**RE: Enterprise Rent-A-Car
5700 San Mateo NE
Grading & Drainage Plans
Engineer's Stamp Date: 05/04/22
Hydrology File: F18D052**

Based upon the information provided in your submittal received 05/04/2022, the Grading & Drainage Plans **are not** approved for Building Permit. The following comments need to be addressed for approval of the above referenced project:

Sheet C-102

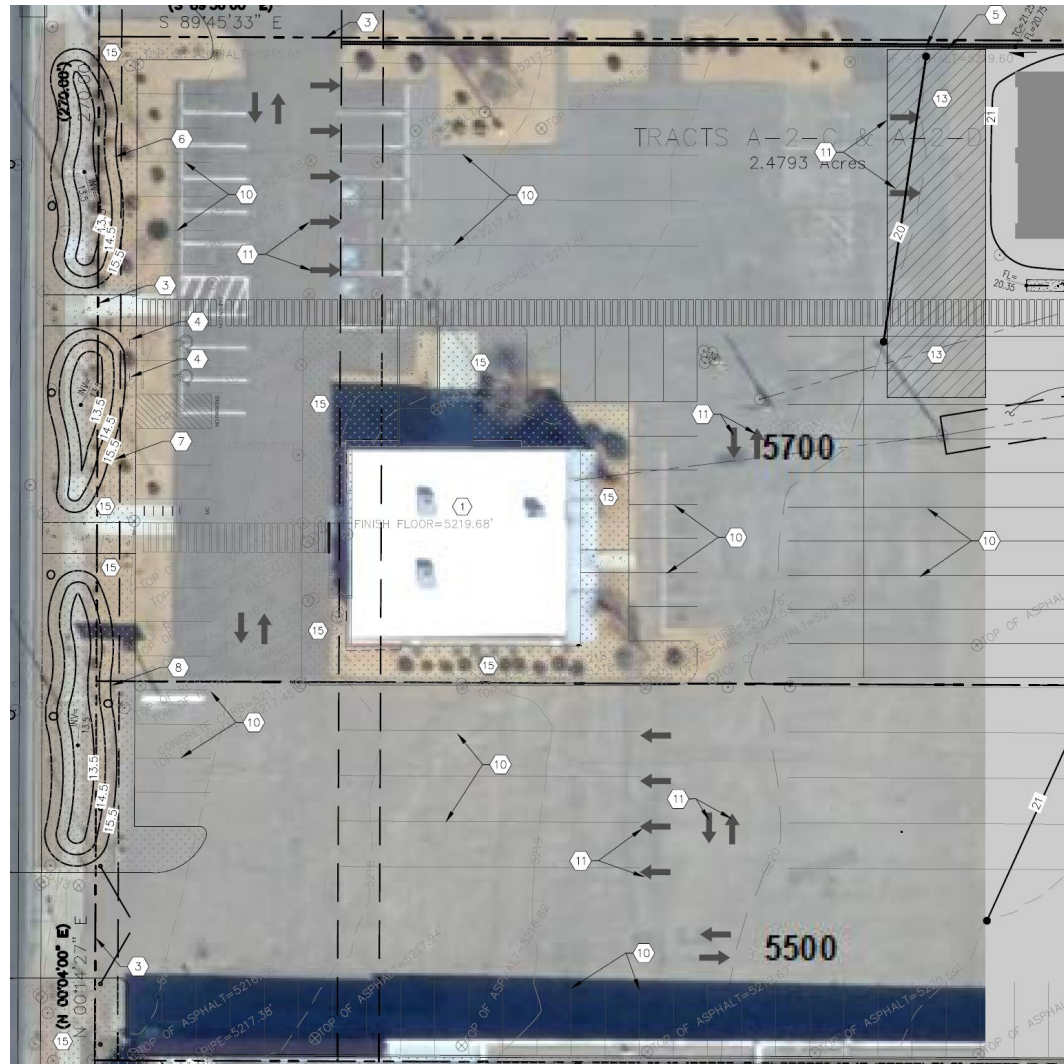
2. Please provide the Benchmark information (location, description and elevation) for the survey contour information provided.
3. Overlaying the latest aerial with the site plan and there are several discrepancies such as the existing landscape areas along the north of the property, and the relocation of the existing ADA spaces. Please verify that an actual topographic survey was done on this site.

C-101

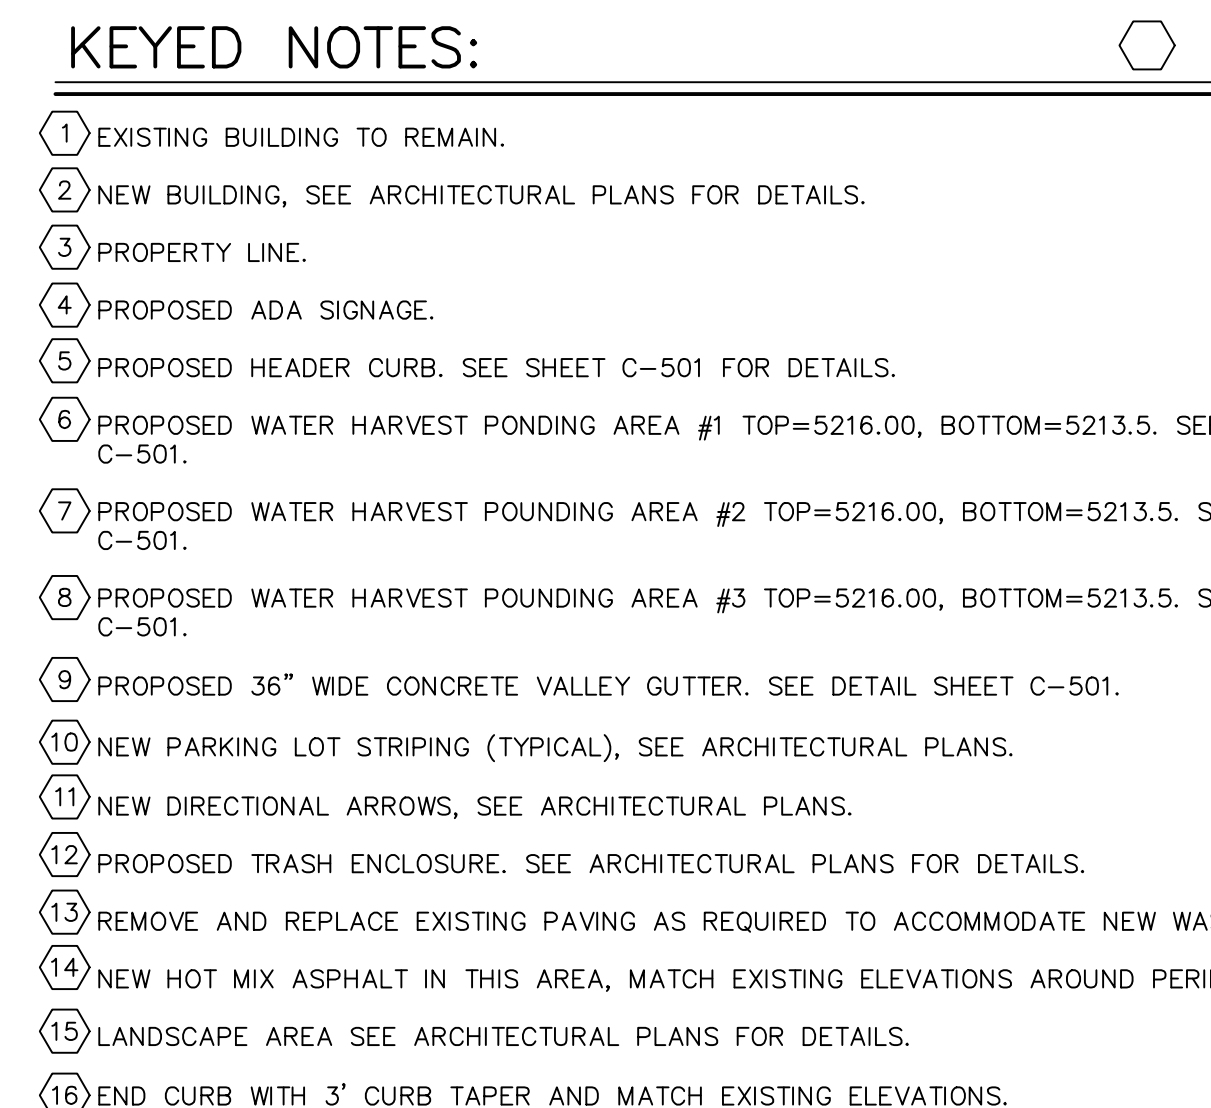
1. Stormwater Quality Ponds cannot be built within the City's R.O.W. Either relocate the ponds on-site or use the Waiver of Management Onsite form and request a Payment in Lieu for the required Stormwater Quality Volume.
